DETAIL 01 - LEAD FLASHING TO EXISTING PARAPET WALL WITH PROJECTING CORNICE
SCALE 1:5 @ A1

CLIENT	TRIDENT
PROJECT	SMITHFIELD BUILDINGS MANCHESTER
TITLE	DETAIL 01 PARAPET
JOB NO.	TRI01
DWG NO.	TRI01-D-AD1.01
SCALE	VARIES
DRAWN	ZS

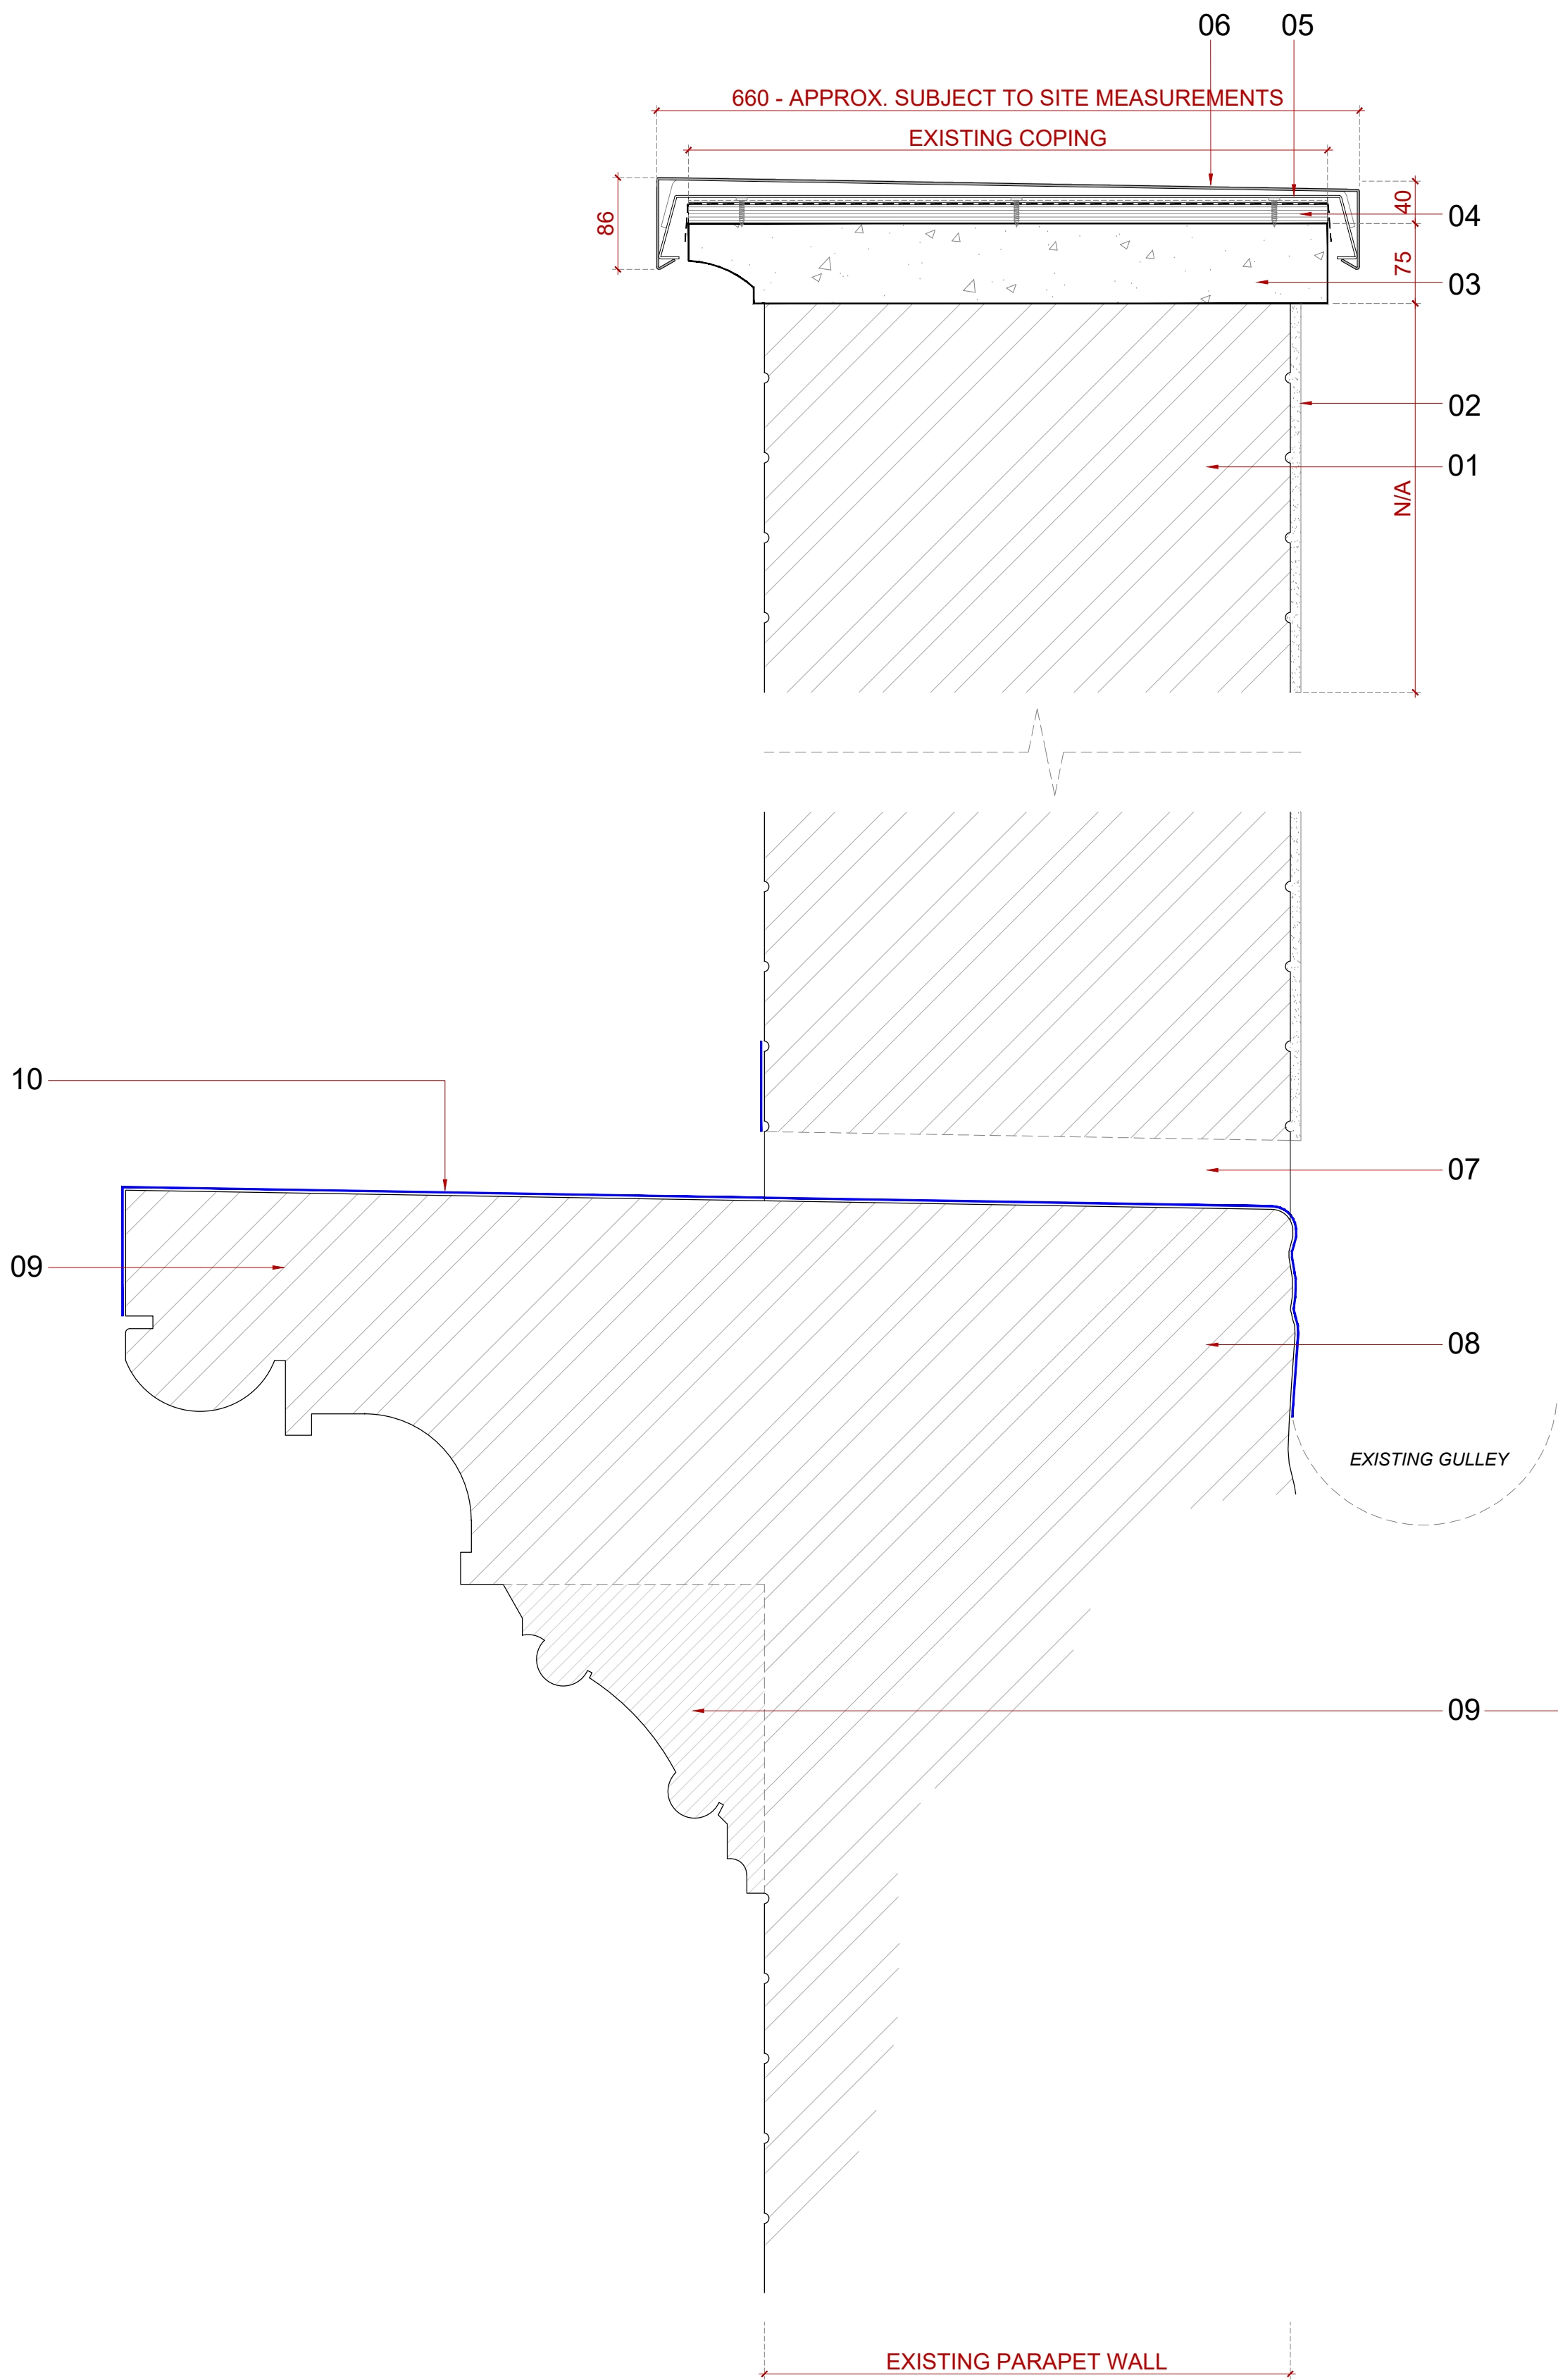
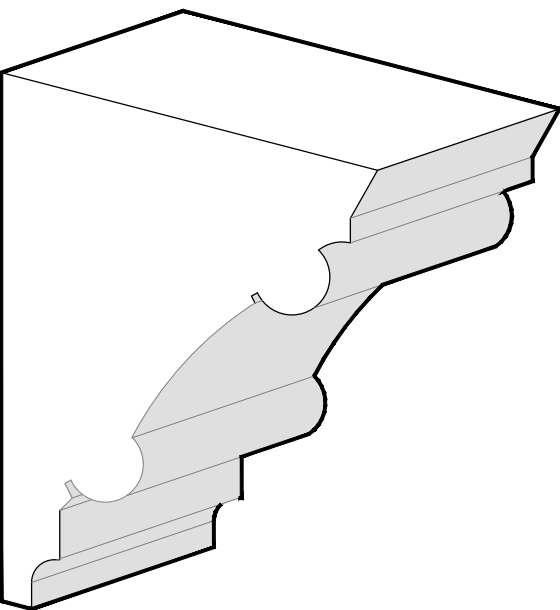
REVISION			
A	PLANNING ISSUE	30.04.25	ZS
B	FLASHING TO BE LEAD NOT ALUMINUM	04.07.25	ZS

06- Coping to be lead, traditional standard finish.
